Central Kitsap Fire and Rescue
Station 45

Bid No. 2022-STA45BUILD-50-01

ADDENDUM # 1
April 20, 2022

LUMINAIRE
SCHEDULE

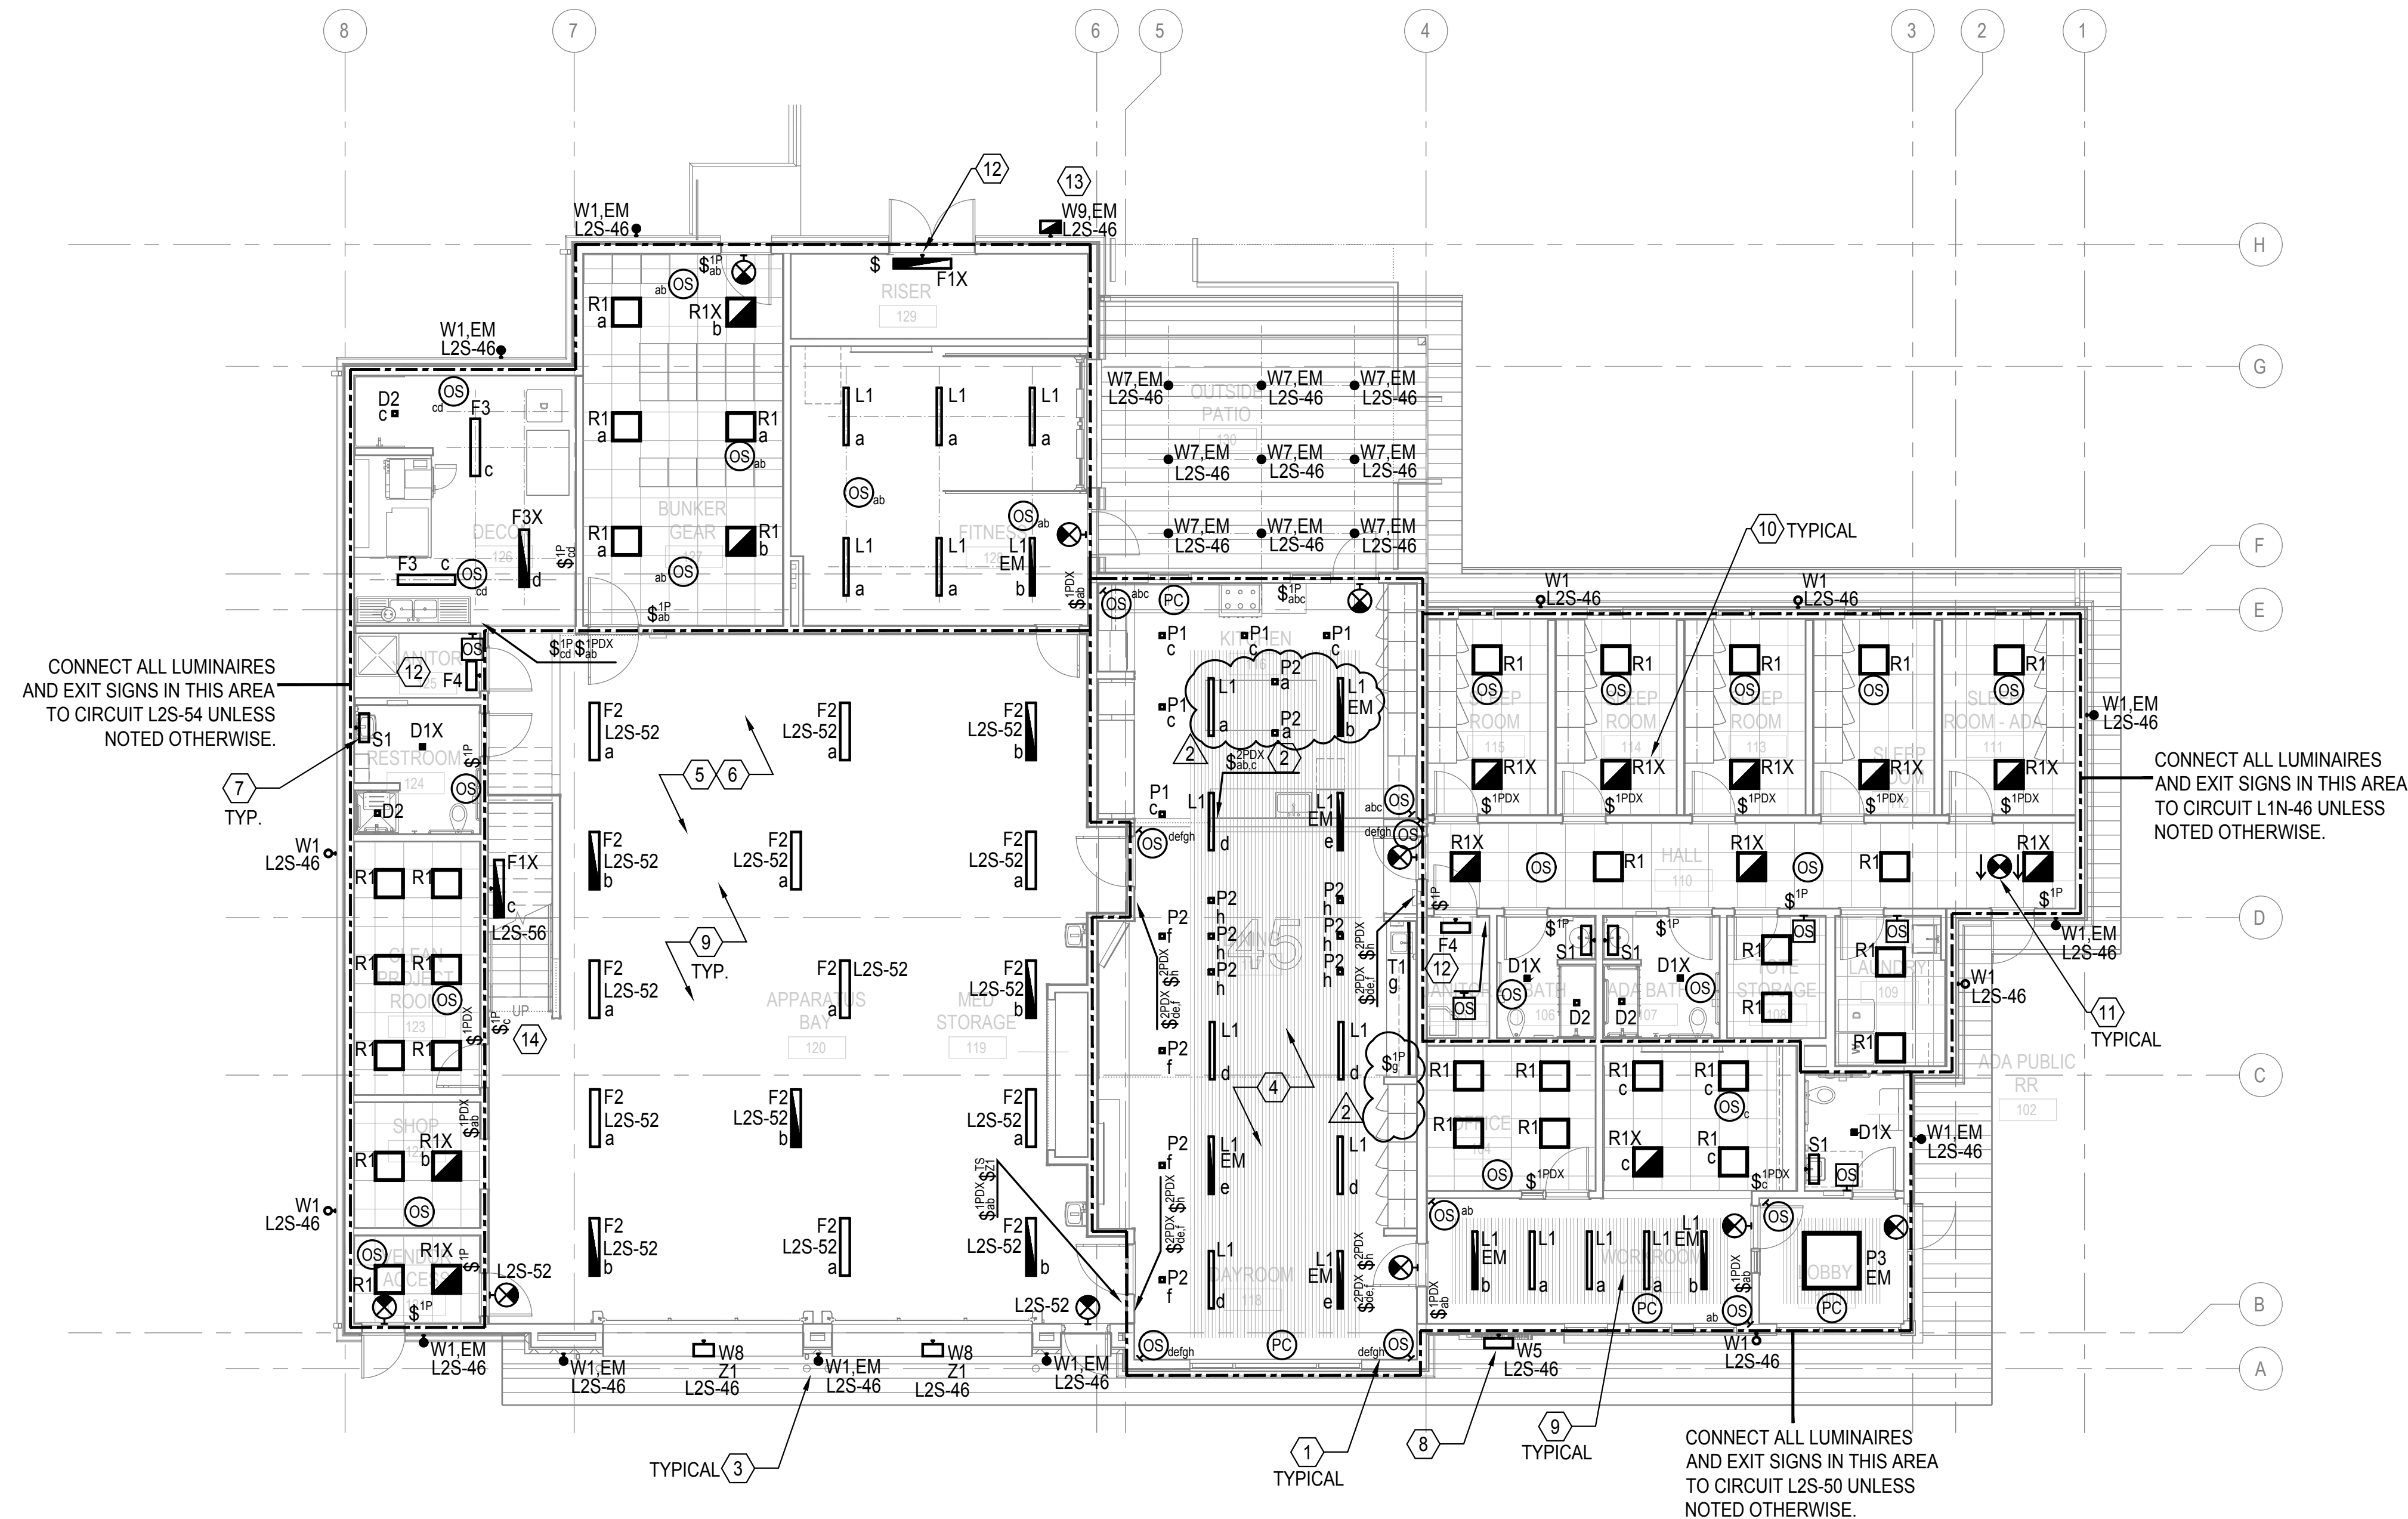
- ITEM 5. DRAWING E22.03
 - a. REPLACE SHEET: Located conduit for future PV.
- ITEM 6. DRAWING E30.01
 - a. REPLACE SHEET: Corrected description for Fixture Type W1 – cylinder specified is direct only.
